United States Nuclear Regulatory Commission Official Hearing Exhibit																									
In the Matter of:	POWERTECH USA, INC. (Dewey-Burdock In Situ Uranium Recovery Facility)

# Safety Evaluation Report for the Lost Creek Project, Sweetwater County, Wyoming, Materials License No. SUA- 1598

Docket No. 40-9068  
Lost Creek ISR, LLC

**U.S. Nuclear Regulatory Commission**

**Figure 2.2-2: Average Monthly Precipitation Collected at Various Stations**

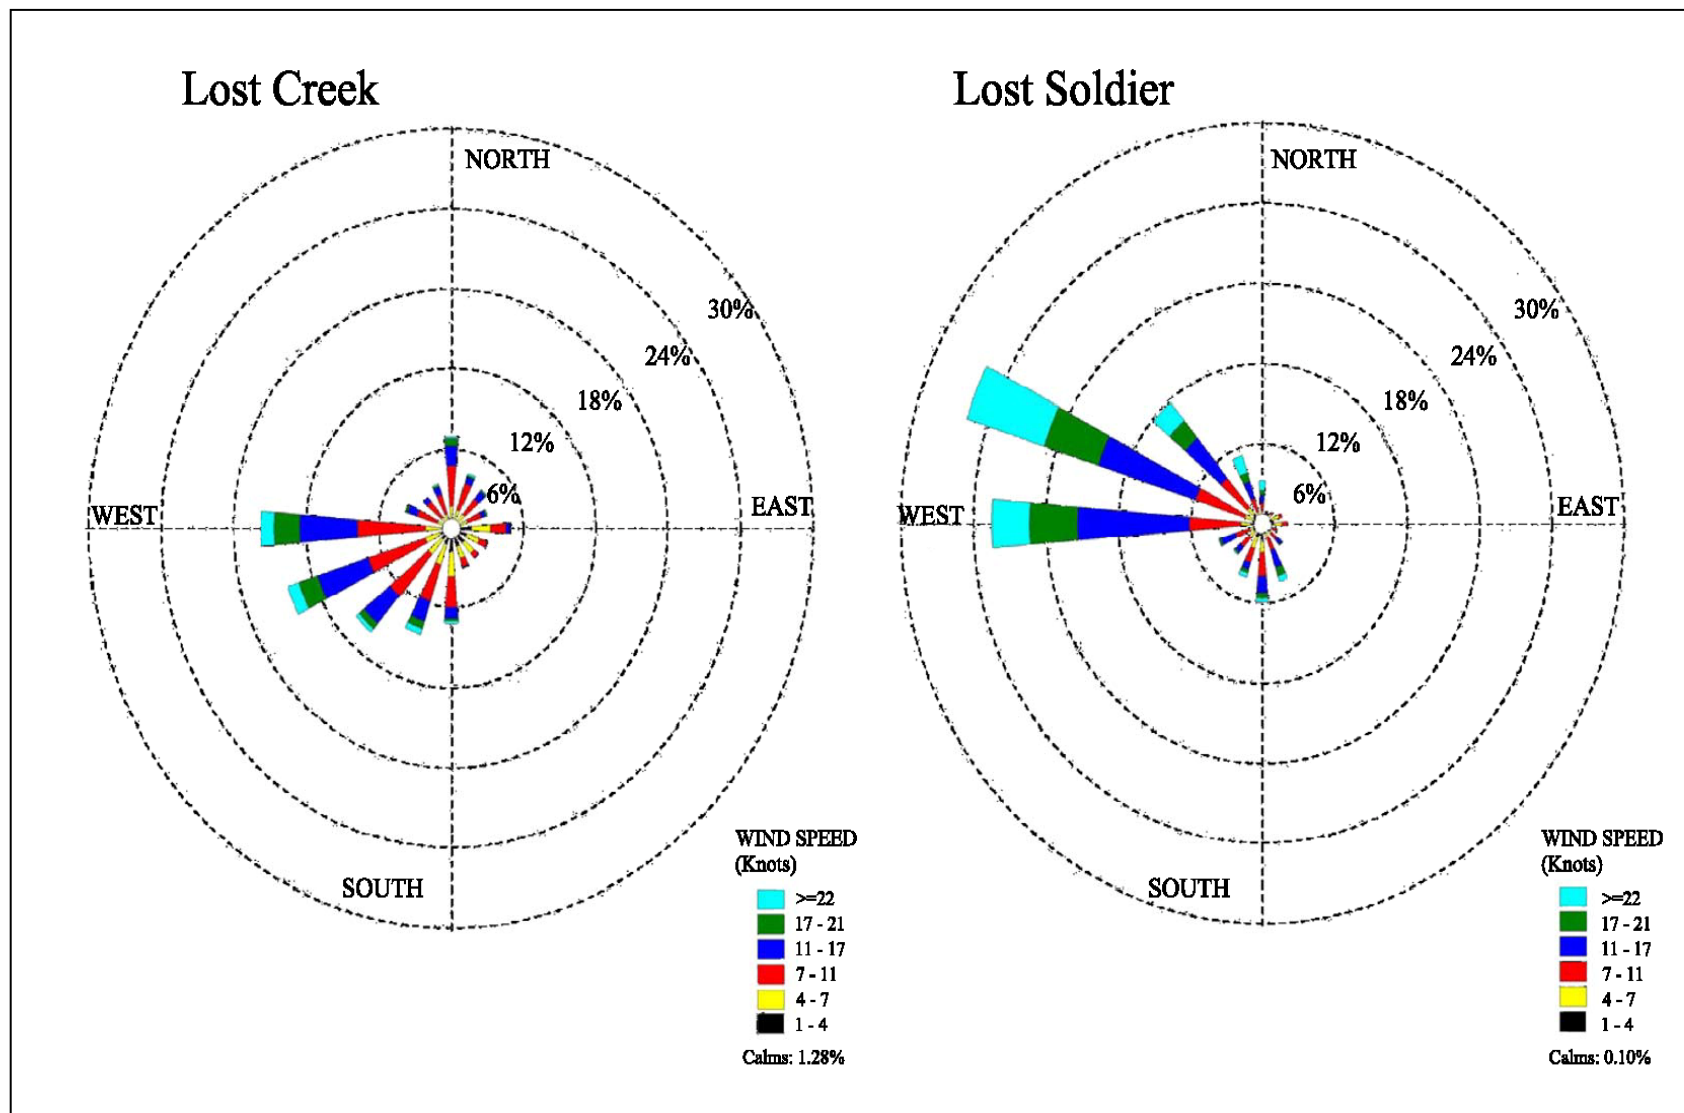
The applicant (LCI, 2010a) compared the average monthly precipitation and temperature data measured during various record periods at several sites to the precipitation and temperatures measured at the LS and LC stations as shown in SER Figure 2.2-2 and SER Table 2.2-1. Staff observed that these data presented do not verify that the data collected at Lost Creek or Lost Soldier are representative of long-term conditions because the periods of collection were not the same at the various sites. In addition, the staff found that it is difficult to compare average rainfall data because the data could have included years with exceptional rainfall or droughts.

**Figure 2.5-1: Surface Water Sampling Locations at Lost Creek**

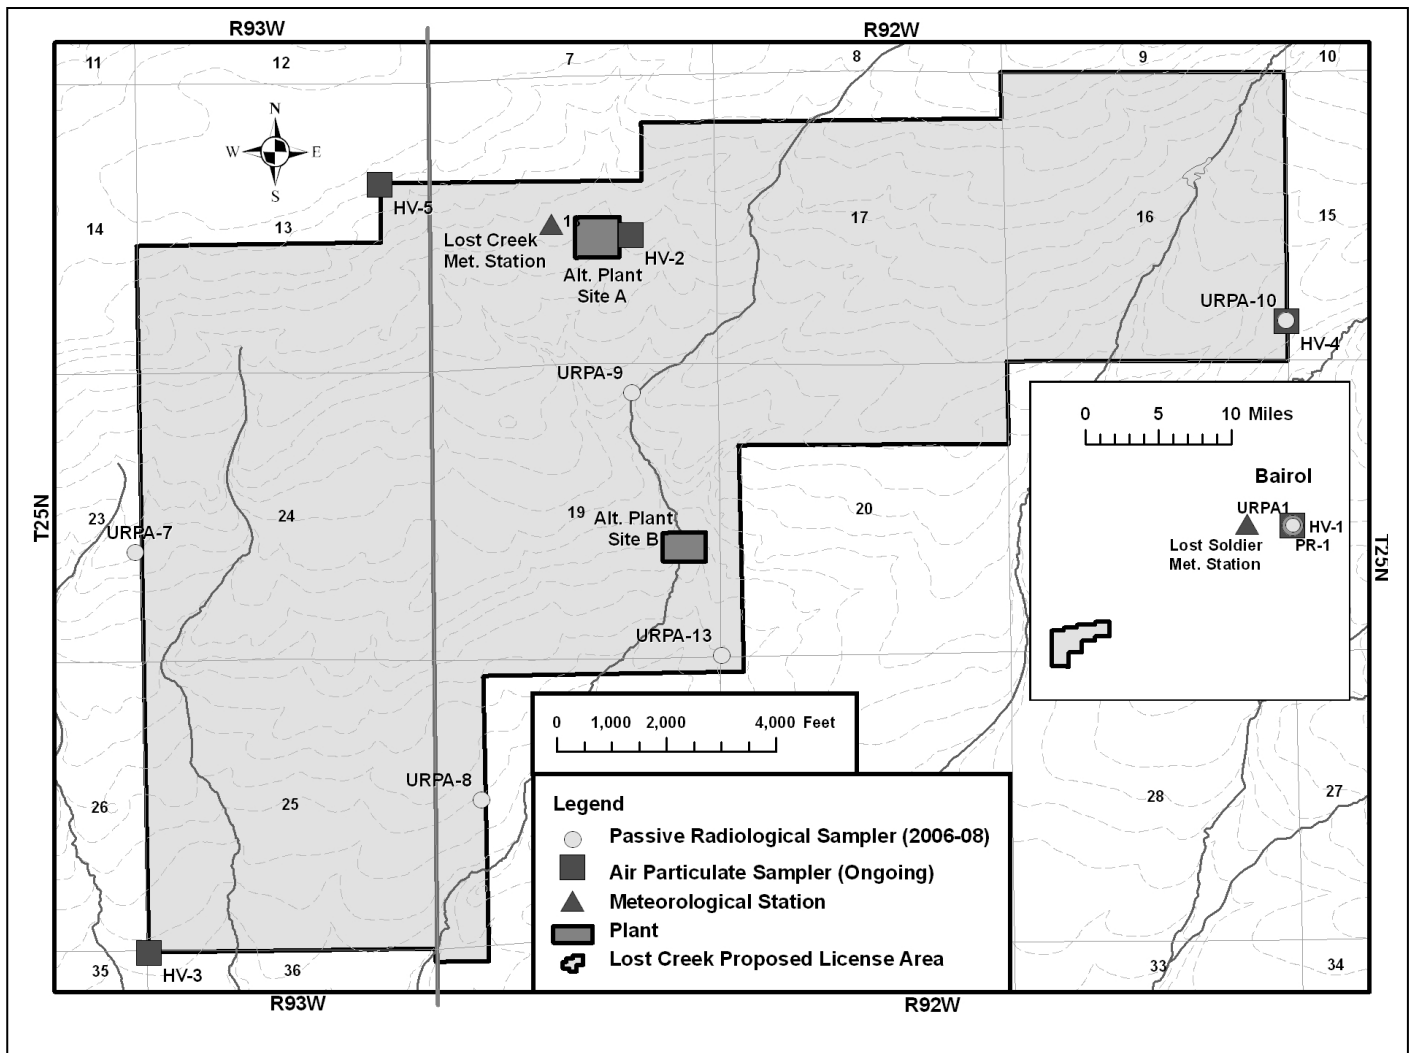
Most radionuclides were below detection limits, except for four samples (LC-1, LC-2, LC-4, and LC-5 in SER Figure 2.5-1) that contained total U concentrations between 3 to 9 µg/ml. Two of these samples, LC-2 and LC-4, had dissolved and suspended U concentrations of 3-4 µg/ml and 5-6 µg/ml, respectively. Radium-226 was only measured in one sample, LC-2, located in a large channel near the center of the license area and ore body. The highest gross alpha activity was also measured at this location. The results met EPA drinking water standards for radionuclides for those measured. However, the applicant did not report results for dissolved Ra-226, as recommended by Regulatory Guide 4.14, nor did it provide a justification for not doing so. The applicant stated that it attempted to collect such samples but could not, because of insufficient snowmelt to collect surface water samples (NRC, 2011c). Based on the information provided by the applicant regarding infrequent rainfall and absence of significant snowmelt, the staff finds the applicant has sufficiently established baseline surface water monitoring and, thus, finds that the applicant's baseline surface water monitoring program is acceptable.

**Figure 2.6-1: Radon, Passive Gamma (URPA #), and Air Particulate (HV-#) Locations**

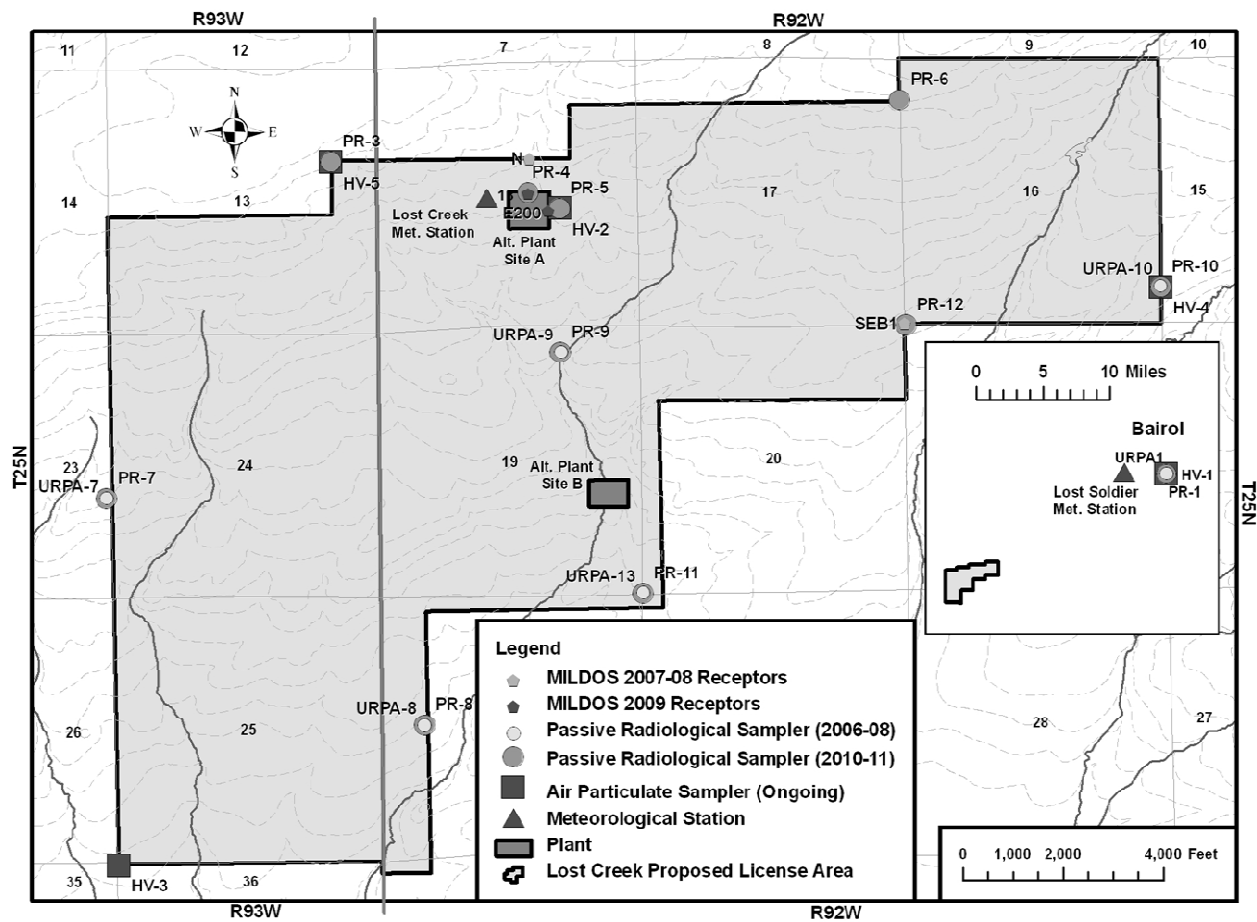
This alternate methodology presented by the applicant consisted of two components. The first component consisted of placing thermoluminescent dosimetry (TLD) in the same locations as the radon samplers. SER Figure 2.6-1 and Table 2.6-1 present the sampling locations and results, respectively. The initial placement of the TLD's and radon samplers (LCI, 2008c) were not at the same locations as the particulate air samplers as recommended in Regulatory Guide 4.14. However, based on additional MILDOS-AREA analyses, the applicant began an additional year of sampling in 2010 (LCI, 2010a). As shown in SER Figure 2.6-3, the applicant placed radon samplers and TLDs at 12 locations in and around the proposed licensed area in

NRC staff finds that the number of samples collected and the surface soil sampling methodology are consistent with Regulatory Guide 4.14, with the exception that the applicant did not collect surface soil samples at air particulate stations as recommended by Regulatory Guide 4.14. In contrast, the applicant (LCI, 2010a) collected additional vegetation and surface soil samples at seven locations determined by the gamma survey and 2009 MILDOS-AREA simulations to range from background conditions to sites predicted to have the maximum radon progeny deposition (see Figure 2.6-5). The applicant stated that it selected the sampling locations were to better define a baseline against which to assess environmental impacts. SER Table 2.6-4 presents these sampling results. As discussed in SER Section 2.6.3.3, the applicant stated that locations F, G, H, and I had higher gamma exposure readings from the direct radiation survey and MILDOS-AREA 2009 simulations predicted the highest deposition of radon progeny at locations D and E. However, in SER Table 2.6-4, the staff observed that Location D had higher gamma exposure readings than Location H. The staff observed that higher exposure rates correlated with the highest concentrations of Ra-226, Th-230, and U in soil. The staff found that Location J results are the lowest concentrations measured for all isotopes and consistent with background conditions as the applicant suggested (LCI, 2010a).

**Figure 2.6-3: Location of Radial Receptors from Plant Center**

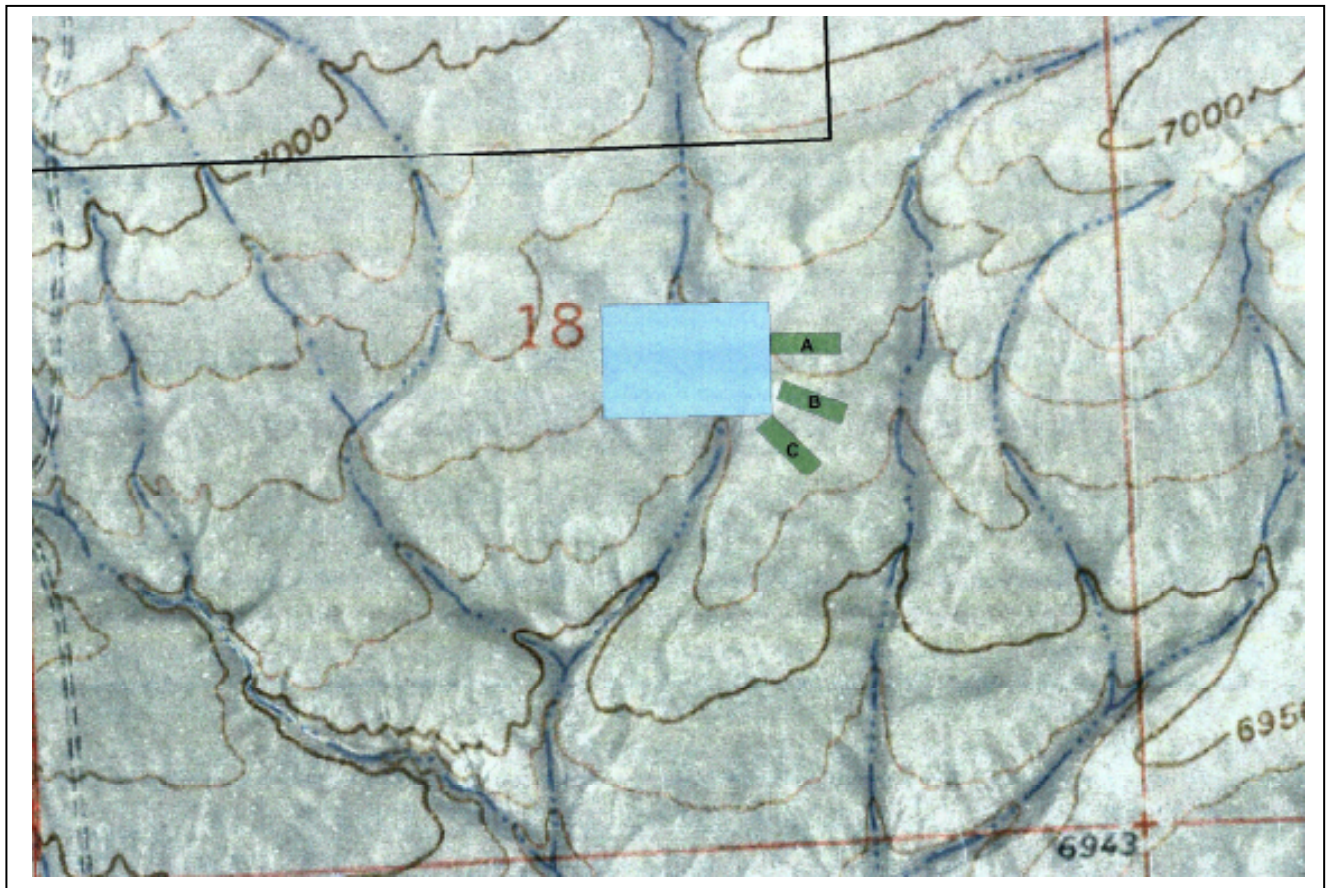
The applicant stated that four of the six highest predicted ground concentrations of radon progeny were within the boundary of the processing plant (square in SER Figure 2.6-3) (LCI, 2010a). The remaining two were outside of the plant-fenced area, but within the permit boundary north and east of the plant. These locations are annotated as N200 and E200, respectively, in SER Figure 2.6-2.

The applicant stated that air particulate samples will be collected continuously at the five locations identified in SER Figure 2.6-3 and analyzed for natural uranium, Th-230, Ra-226, and Pb-210 in accordance with Regulatory Guide 4.14. Sampler HV-2 is located approximately 200 m east of the plant at a location that the applicant's models predicted would have the highest soil deposition as described in section 2.9.4 of the technical report. Sampler HV-3 is located at a position that the applicant stated had the lowest total effective dose equivalent (TEDE) of any modeled receptor. Samplers HV-4 and HV-5 are located at receptor sites that the applicant stated the model predicted to be at intermediate concentrations and are downwind of the plant and wellfields.

During operations, the applicant will monitor radon gas and passive gamma radiation at the same locations as discussed in Section 2.9.4 of the technical report and shown in SER Figure 2.6-3. There are 12 sampling radon sampling locations, of which five of these sample sites are co-located with the air particulate samplers as recommended in Regulatory Guide 4.14. The staff finds that the air particulate and radon environmental monitoring locations are consistent with Regulatory Guide 4.14 and therefore, acceptable to meet the operational environmental monitoring requirements in Criterion 7 of Appendix A to 10 CFR Part 40.

**Figure 2.6-4: 2008 Vegetation Sampling Locations**

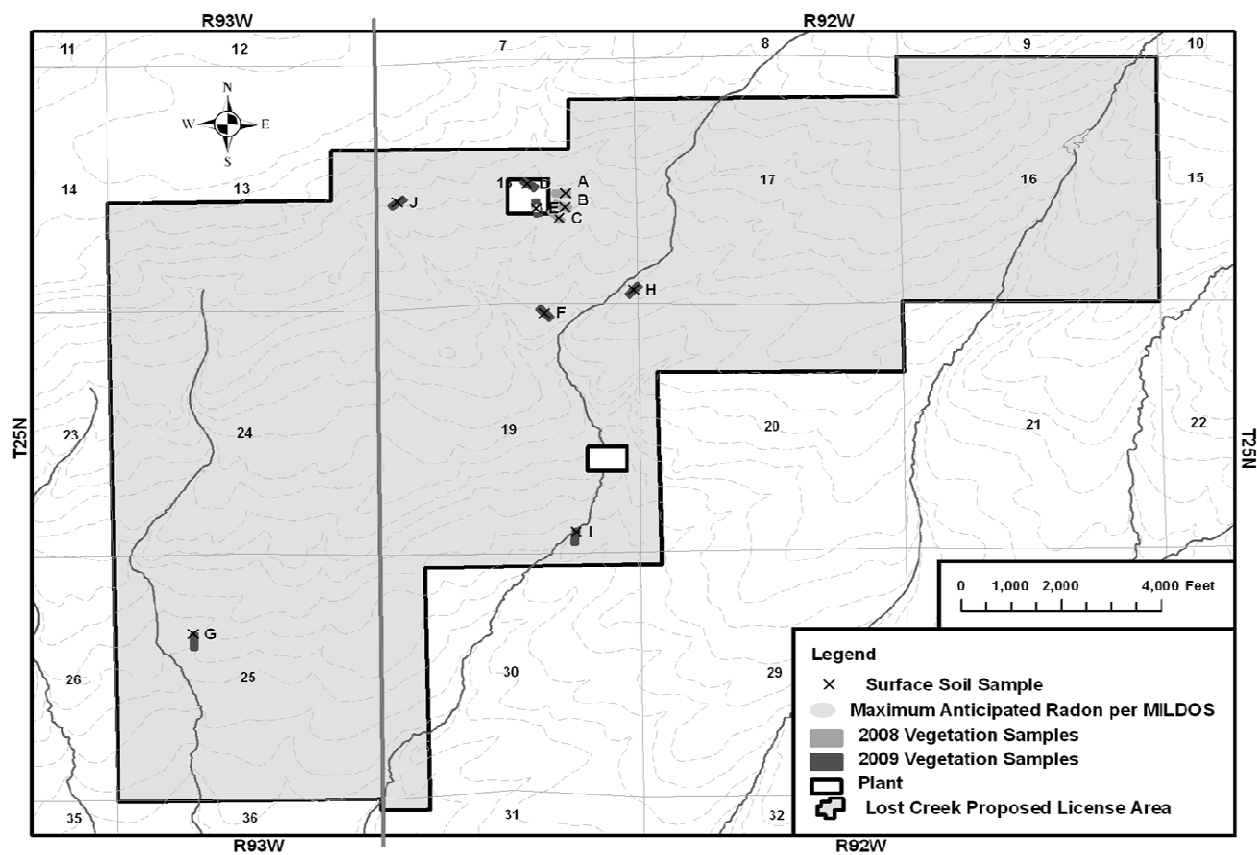
The applicant collected vegetation samples in 2008 and analyzed the samples for U-natural, Th-230, Ra-226, Pb-210, and Po-210. Sampling locations and results are shown in SER Figure 2.6-4 and SER Table 2.6-2, respectively. For purposes of evaluating preoperational conditions for the anticipated dryer installation (LCI, 2010c), NRC staff finds the vegetation sampling program consistent with recommendations in Regulatory Guide 4.14 because the applicant collected vegetation samples from three locations near the proposed plant site in three different sectors having the highest predicted airborne radionuclide concentration due to operations. Therefore, the staff finds the vegetation baseline vegetation sampling acceptable for addressing this aspect of the operations. However, the sampling program did not address the effects of radon progeny deposition, as discussed below.
